Work Order ID 102923

Item Name: Basket Hoop

DESIGN #	DRAWN BY CP	DART AEROSPACE LTD HAWKESBURY, ONTARIO, CANADA	
CHECKED #	APPROVED #	DRAWING NO. D3166	REV. A SHEET 1 OF 1
DATE 02.07.10		TITLE BASKET HOOP	SCALE NTS
A	02.07.10	NEW ISSUE	
A1	04.04.08	38+/-1 WAS 36.0

DRAWING NO. D3166	TITLE BASKET HOOP	REVA1	DART AEROSPACE LTD ENGINEERING ORDER		D.E.O. NO. D3166-A-2	SHEET NO. 1 OF 1	SCALE NTS
DRAWN AJS	CHECKED	MFG. APPR.	APPROVED	DE APPR.			
DATE 08.12.11	DATE 08.12.15	DATE 08/12/15	DATE 08/12/16	DATE 08-12-16

D3166-1 BASKET HOOP

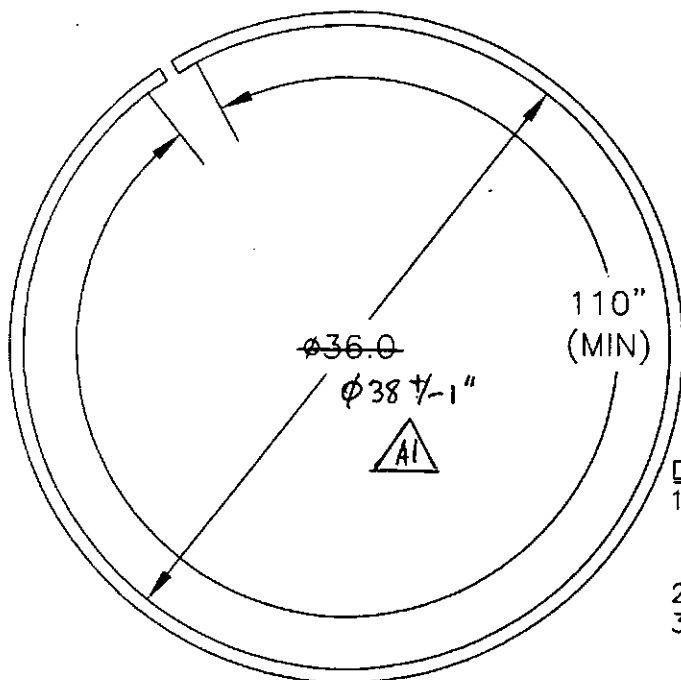
1) MODIFY MATERIAL NOTE FOR D3166-1 AS SHOWN:

WAS:

1) MATERIAL: AISI 304/316 SS SQUARE TUBING,
0.75" x 0.75" x 0.063 WALL, 60.00" LONG
(REF DART SPEC. M304TS0.750W.063)

2) MODIFY MATERIAL NOTE FOR D3166-3 AS SHOWN:

WAS:

1) MATERIAL: AISI 304/316 SS SQUARE TUBING,
0.75" x 0.75" x 0.063 WALL, 120.00" LONG
(REF DART SPEC. M304TS0.750W.063)

IS:

1) MATERIAL: AISI 304/316 SS, 3/4 X 3/4 X 0.065 WALL SQUARE TUBING,
60.00" LONG
REF. DART SPEC M304TS0.750W.065

IS:

1) MATERIAL: AISI 304/316 SS, 3/4 X 3/4 X 0.065 WALL SQUARE TUBING,
120.00" LONG
REF. DART SPEC M304TS0.750W.065
